## **THE CEDARS SUBDIVISION**

APPLICATION NUMBER 6 DATE September 3, 2015  
 APPLICANT The Cedar's Avenue Subdivision Resubdivision of Lot 1  
 REQUEST Subdivision

# THE CEDARS AVENUE SUBDIVISION RESUBDIVISION OF LOT 1

# DETAIL SITE PLAN

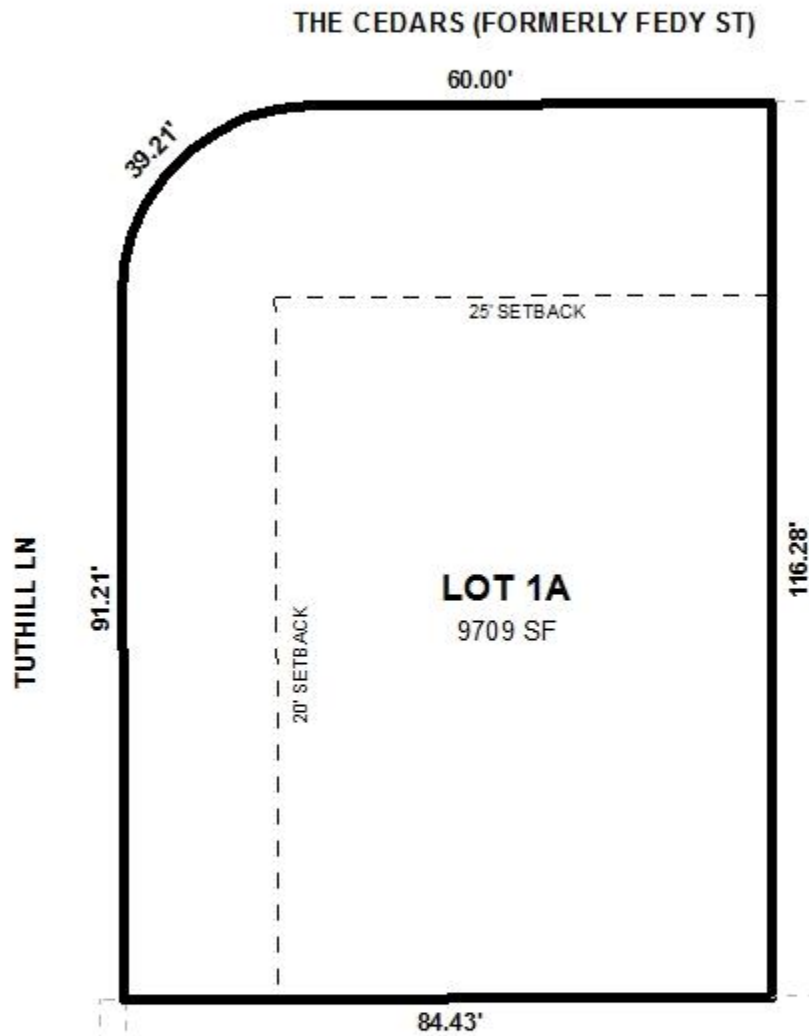
The site is located at the corner of Tuthill Lane and The Cedars, both minor streets with curb and gutter. The plat, as illustrated, has sufficient dedication providing 25' from the centerline of both Tuthill Lane and The Cedars. The plat also depicts dedication of a corner radius at this intersection in compliance with Section V.D.6. of the Subdivision Regulations.

As a means of access management, the preliminary plat has provided a note stating that the lot is limited to one curb cut, with the size, location and design to be approved by Traffic Engineering and conform to AASHTO standards. This note should be retained on the Final Plat, if approved.

The proposed lot size is provided in square feet and acres, and would exceed the minimum required lot size in Section V.D.2. of the Subdivision Regulations. This information should be retained on the Final Plat, if approved.

- 1) Provision of 7 copies of the recorded plat for The Cedars Subdivision prior to the signing of the Final Plat;
- 2) Retention of the 25' centerline of both Tuthill Lane and The Cedars, as shown on the preliminary plat;

- 3) Retention of the corner radius at the intersection of Tuthill Lane and The Cedars in compliance with Section V.D.6. of the Subdivision Regulations, as shown on the preliminary plat;

- 4) Retention of the 25' minimum building setback along The Cedars;
- 5) Retention of the 20' minimum building setback along Tuthill Lane;
- 6) Retention of the note on the Final Plat, stating that the lot is limited to one curb cut, with the size, location and design to be approved by Traffic Engineering and conform to AASHTO standards;
